In the matter of Proposed Plan Change 2 to the Rotorua District Plan

JOINT WITNESS STATEMENT - STORMWATER

EXPERT CONFERENCING – STORMWATER AND FLOODING

Notes from caucusing on the way forward (dated 25 August 2020)

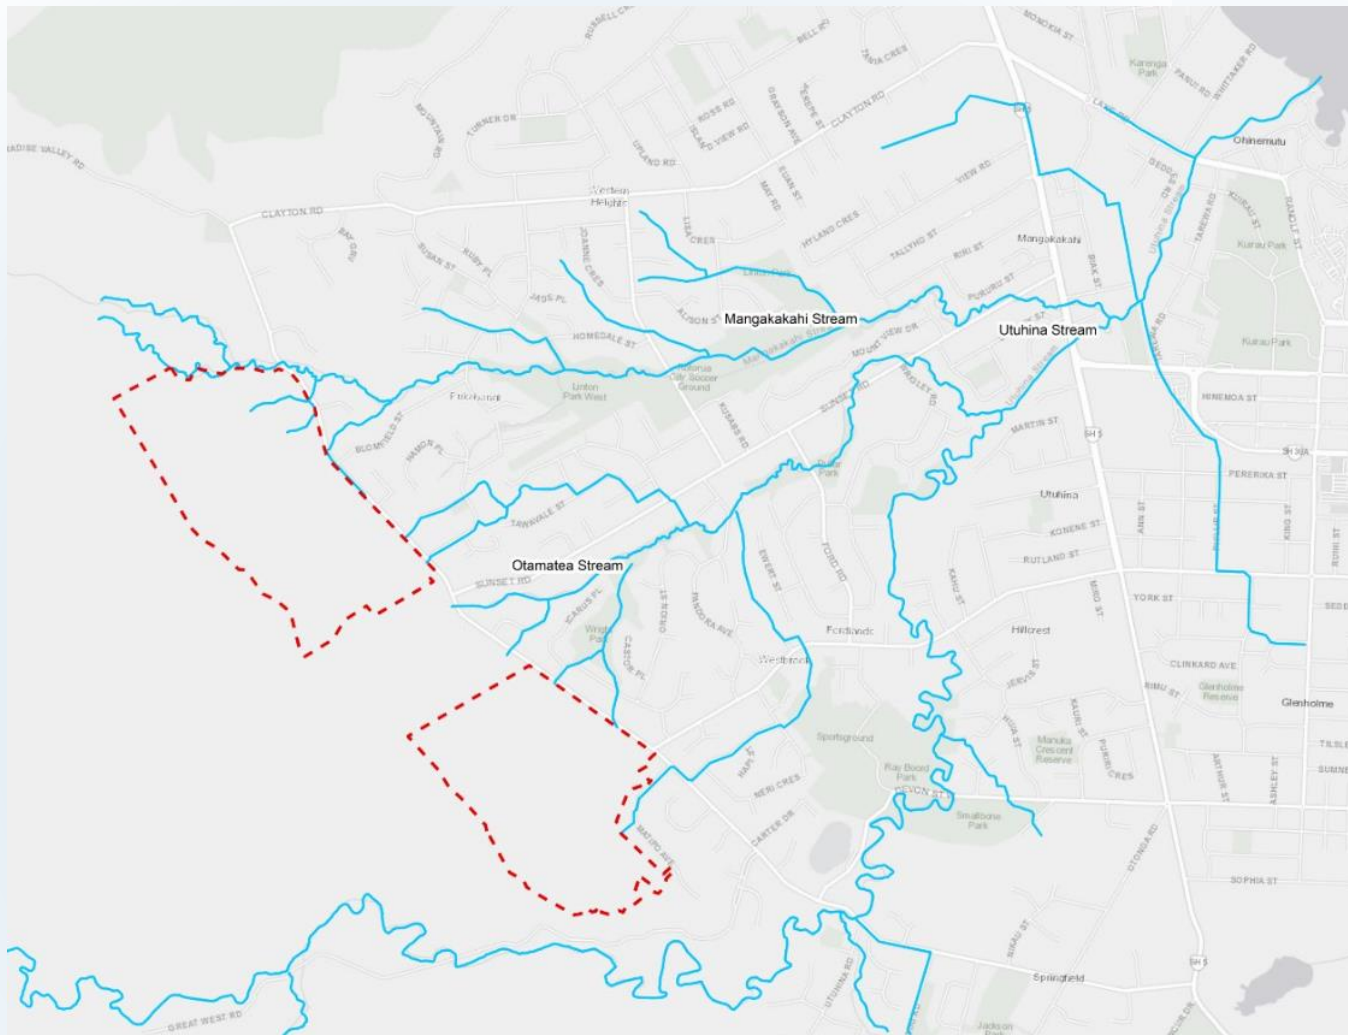
Drain down time

- 50% of volume in 24 hours after end of event, total drain maximum 4 days from end of event

- Maybe from time of when pond level starts dropping

- Or from time that lower orifice only operates

- 50% of volume only served by lower orifice must drain in 24 hours

20. The experts caucused and agreed an approach to the position reached. This approach is summarised in the attached page of notes, and can be described as follows:
 - a. The drain-down performance of proposed ponds needs to be checked against relevant criteria. Several criteria were proposed, as shown in the notes, with the following performance agreed as the most appropriate:
 - i. 50% of the volume stored within detention ponds that can only drain via the lowest outlet, shall drain within 24 hours. This criterion is highlighted in yellow in the attached notes.

- b. Should the proposed ponds not meet the above performance criterion, then the pond configuration shall be re-designed.
- c. Following such re-design, the revised outlet analysis (as described in 10.b above) shall be provided to BoPRC for input to the GUCM.
- d. The GUCM and the WSP models shall be used to assess the performance as described in 11 above.
- e. Should the revised ponds meet the required performance criterion, then the approach can be confirmed and the results accepted.
- f. An amended stormwater report is required that addresses the re-analysis described in the points (a) to (e) above, and also the language changes outlined in items 12.a and 13 above.
